SB-10053926-7688

TECHNICAL BULLETIN
LTB00594NAS1
27 SEP 2013

SECTION: 414-01**Battery Positive Post and Battery Box Modification****AFFECTED VEHICLE RANGE:****Range Rover Sport (LW)**

E159911

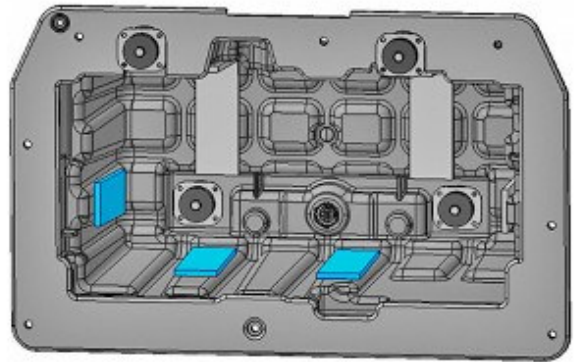
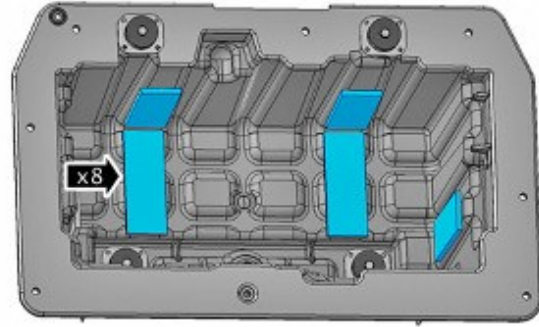
3. Apply eight (8) 120x45x6mm Rubber Snubber Pads.

- Pads 80-90mm from top surface.

E159912

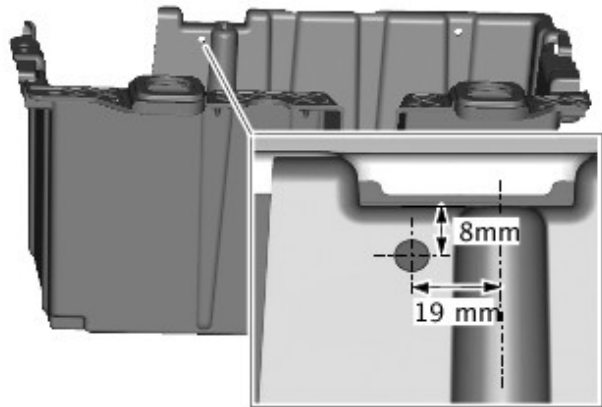
4.  **NOTE: The 6mm hole is to be drilled in the rear right corner of the battery box.**

Drill 6mm hole for cable fir-tree fixing.

E159911

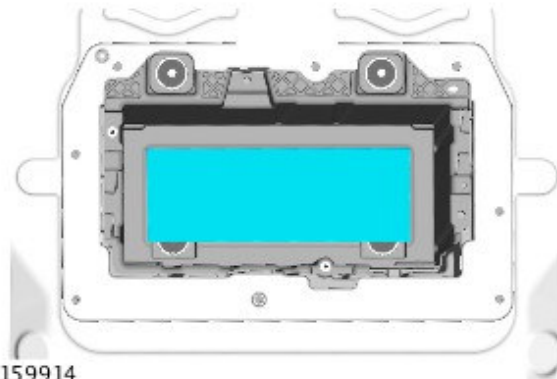
6. Fit battery pad.

E159914

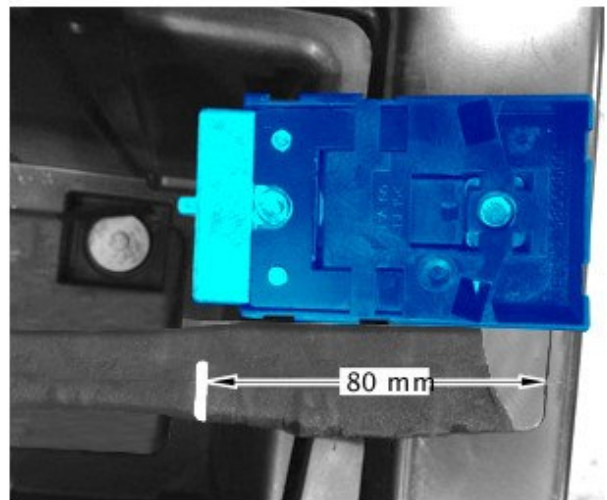
7. Position of clip 80mm from end of terminal.

E159915

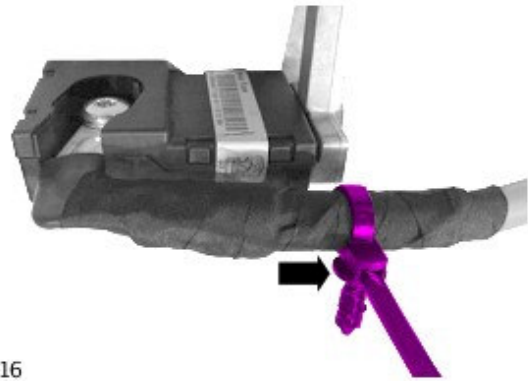
8. Install new clip.

E159909

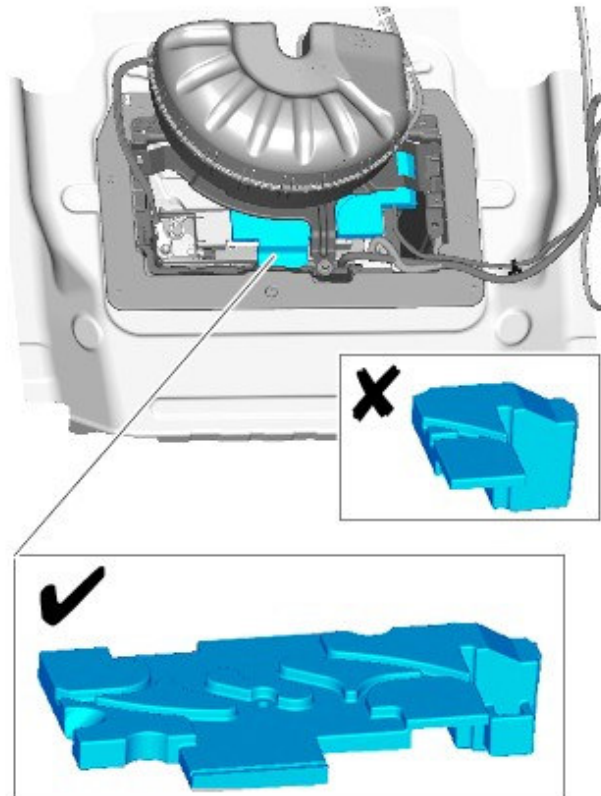
9.  **CAUTION: The correct Foam EPP pad must be present; without the correct pad, battery is not restrained and will lead to premature failure.**

Check the correct foam pad is fitted.

- If the correct pad is fitted, continue to the next step.
- If the correct pad is not fitted, install the correct pad.
